LES-14-00119-NRC

Louisiana Energy Services, LLC
NRC Docket No. 70-3103

Subject: Safety Analysis Report (SAR) Update

Enclosure 1
Marked up version of the Safety Analysis Report
(revision bars, strikethroughs and underlines utilized)

Figure 2.1-2 LES National Enrichment Facility Operating Organization

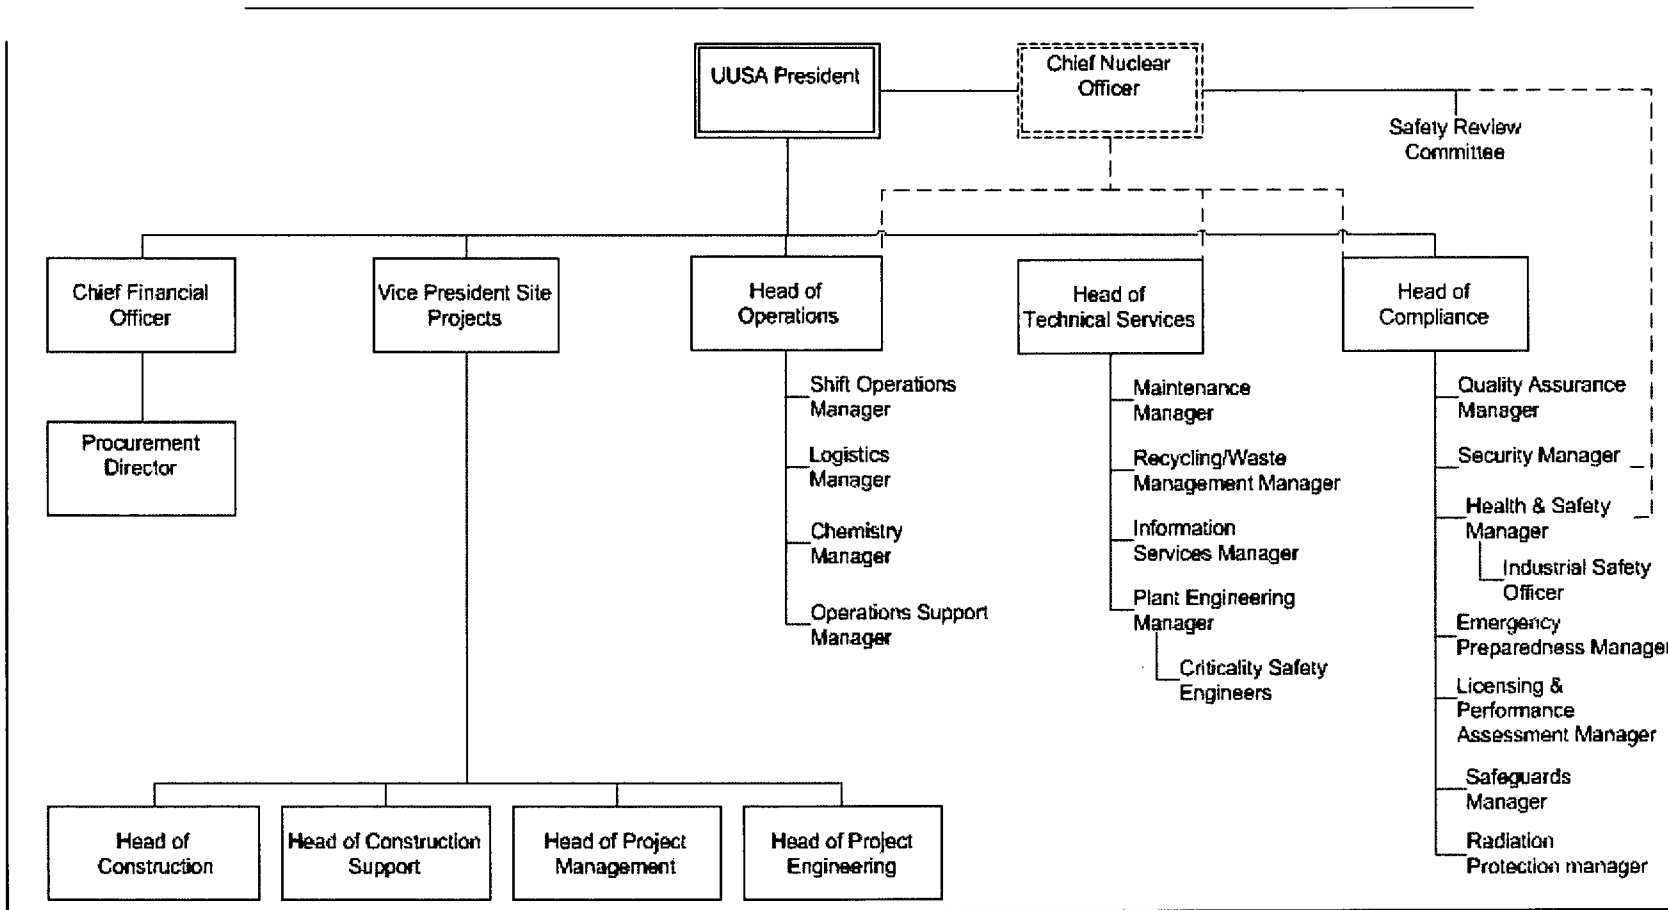
The ~~Health Safety and Environmental Manager~~ Health and Safety Manager reports to the Head of Compliance and has the responsibility for assuring safety at the facility. The ~~Health Safety and Environmental Manager~~ Health and Safety Manager works with the other facility managers to ensure consistent interpretations of health and safety, ~~and environmental requirements~~, performs independent reviews, and supports facility and operations change control reviews.

LBDCR-14-0006
